URGENT Field Safety Notice

MR systems terminal connections in the general Mains Distribution Unit (g-MDU) may produce a Thermal Event

19-April-2024

Figure 1. Hotspot on terminal connection of g-MDU

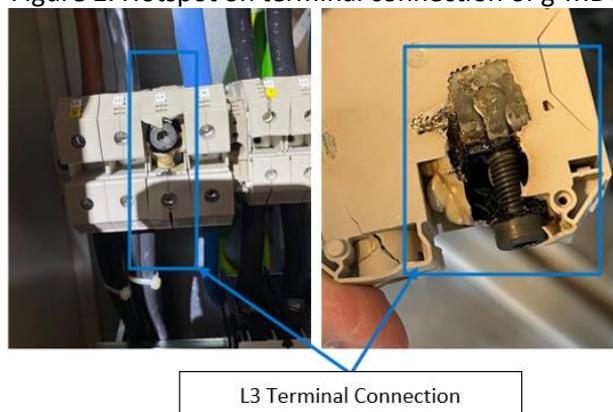
Philips has identified an issue where the g-MDU (global Mains Distribution Unit) L3 terminal connection may become loose creating a hotspot (see figure 1) that may cause smoke/fire to alarm in the hospital's technical room. The g-MDU, located in the technical room, is the single-entry point for the hospital electricity supply and distributes the electricity toward the various cabinets and components of the MR Scanner.

Philips has received five (5) complaints of burnt g-MDU terminal connections, and smoke /burning smell in the technical room associated with the issue. There was no report of injury or serious harm.

Philips will contact you to schedule time for a Field Service Engineer (FSE) to visit your site to inspect the g-MDU connections in the technical room and apply the proper torque to the connection if necessary. (reference FCO78100582). Philips plans to start implementing corrections in July 2024.
